CONSENTED SCHEME 2009/4910 - WEST ELEVATION PROPOSED

CONSENTED SCHEME 2009/4910 - SOUTH ELEVATION PROPOSED

CONSENTED SCHEME 2009/4910 - NORTH ELEVATION PROPOSED

CONSENTED SCHEME 2009/4910 - NORTH ELEVATION (ANNEX) PROPOSED

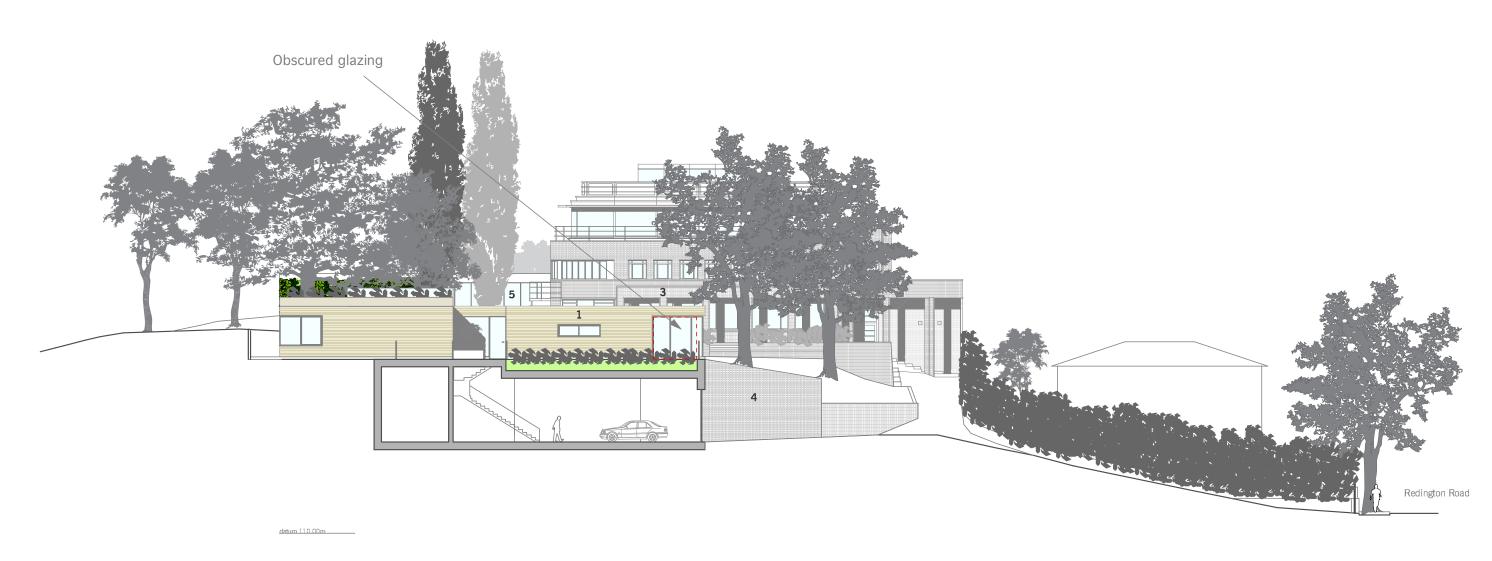
Rev B - 091009

Dining room reduced north by 500mm.

Kitchen moved north.

Site fence of north boundary to 89 Redington Road indicated.

Rev A

Planters and guarding added to roof of annex to make it non-accessible.

Picture window added to west elevation of rear extension.

Context of 85A added to drawing.

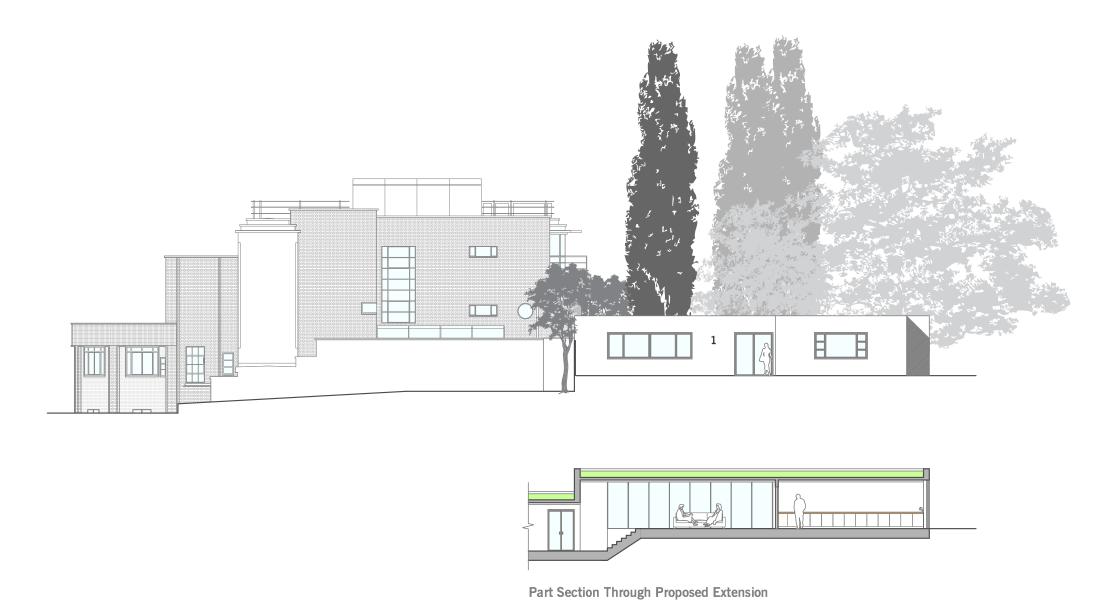
Rev B - 091009

Basement level lowered.

Non-accessible low level planter added to south of annex.

1.2m glazed screens added to prevent access and overlooking.

1/3 of library window specified obscured glass and non-openable.

Planters and guarding added to roof of annex at rear.

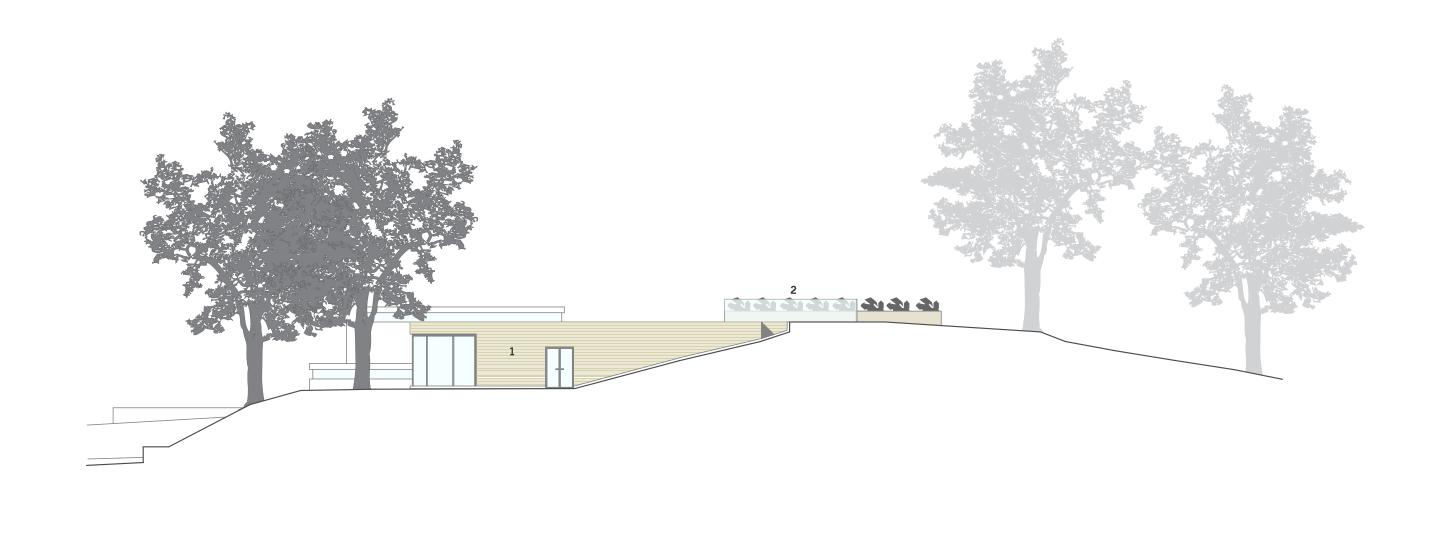
Rev A - 091009

Dining room and kitchen moved west to protect root ball of poplar T6.
